# Access Compliance Report

## Public Rights-of-Way (Curb Ramps)

Intersection ID: 10025397	Main Street: E_ARROWOOD_RD	Cross Street: N/A	Location: NE
ADA ID: 88ED0E878DB2	Ramp Type: Directional1	Initial Pass/Fail: Fail	Overall Compliance: No
		Severity Score: 12.5

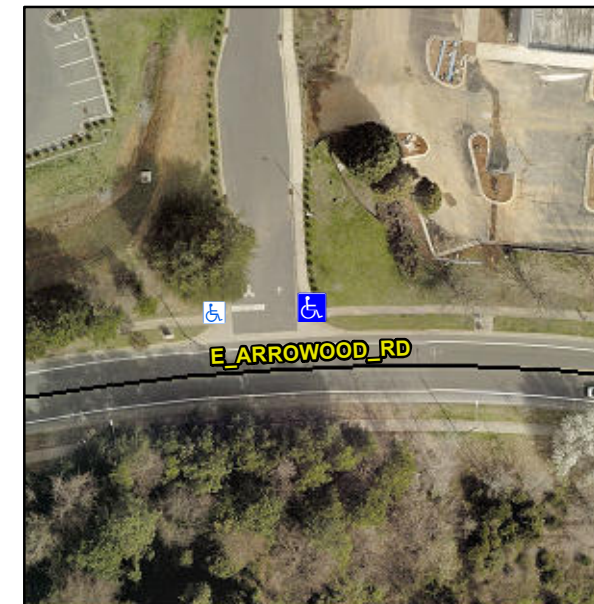
**R304.5.3**

Compliance	Description	Data	Compliance	Description	Data
N/A	Ramp Length (in)	131.0	N/A	Grade Break?	N/A
Yes	Ramp Width (in)	72.0	N/A	Grade Break Slope (%)	0.0
Yes	Ramp Slope (%)	3.1	N/A	Grade Break XSlope (%)	0.0
No	Ramp XSlope (%)	5.6			
N/A	Flare Type LT	N/A	N/A	Flare Type RT	N/A
N/A	Flare Slope LT (%)	N/A	N/A	Flare Slope RT (%)	0.0
N/A	Flare Traversable LT?	N/A	N/A	Flare Traversable RT?	N/A
N/A	Landing Length (in)	0.0	N/A	DWS Provided?	N/A
N/A	Landing Width (in)	0.0	N/A	DWS Contrast?	N/A
N/A	Landing Slope (%)	0.0	N/A	DWS Length (in)	N/A
N/A	Landing X Slope (%)	0.0	N/A	DWS Full Width?	N/A
N/A	Landing Curb? (Y/N)	N/A	N/A	DWS Offset LT (in)	N/A
N/A	Shared Landing?	N/A	N/A	DWS Offset RT (in)	N/A
N/A	Gutter Ponding?	0.0	N/A	Gutter Slope (%)	N/A
N/A	Gutter Lip Ht (in)	0.0	N/A	Gutter X Slope (%)	N/A
N/A	Painted X Walk1?	No		Road Slope (%)	1.1
	X Walk 1 Direction	To W		Road X Slope (%)	2.3
	X Walk 1 Width (in)	N/A		Clear Space?	N/A

**Remove & Replace Entire Ramp.**
